Access Design Assessment Report

Aberdeen Valley Fair  
Aberdeen NSW 2336

Project: Aberdeen Valley Fair  
 Document Type: Access Design Assessment Report  
 Report Number: P217\_081-2 (ACCESS) LD

**Figure 01 – Door clear opening width**

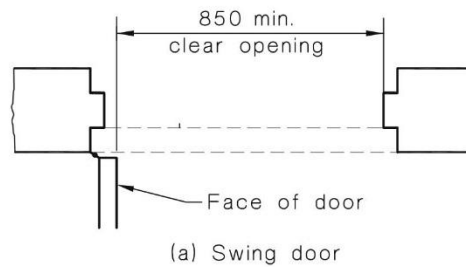
- (i) All doors to have a minimum 850mm clear width and appropriate latch side clearance compliant with AS1428.1-2009; (See **Figure 01** below)—
